# Rezoning Transportation Analysis

Petition Number: 2021-096

Date	Description
8-20-2021	First Review (DBS)
9-17-2021	Second Review (WB)

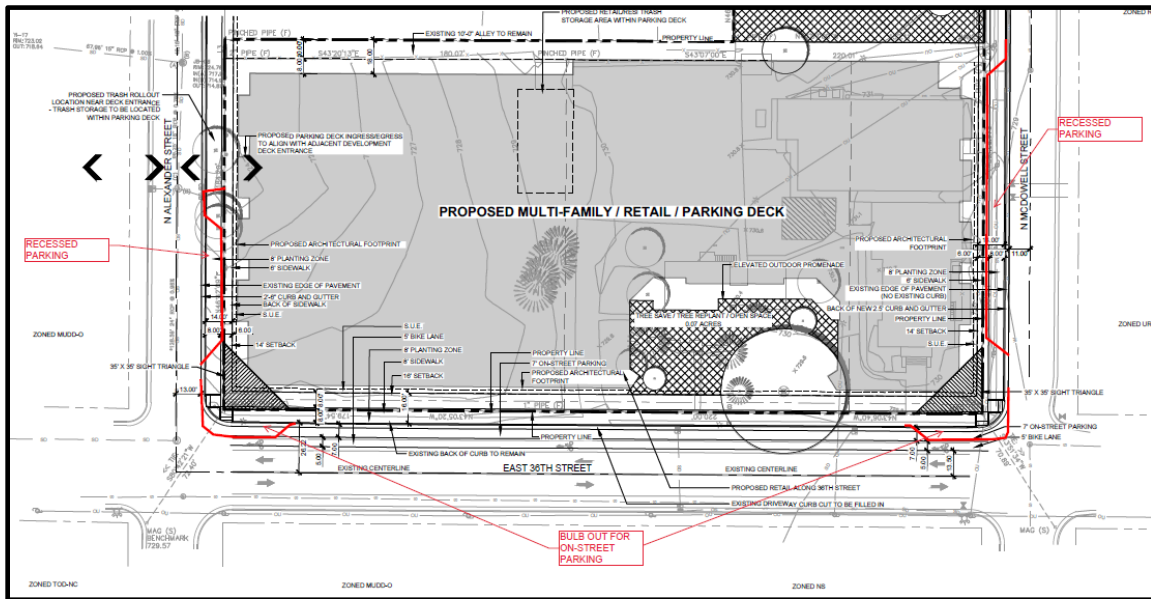
- 8. NEW COMMENT (09.17.2021)**  
Revise site plan to construct bulb-outs on East 36th Street at the corners of at North Alexander Street and North McDowell Street. Provide recessed on-street parking on North Alexander Street and North McDowell Street as SHOWN in the graphic below. New comment in response to request from Noda Neighborhood Board.
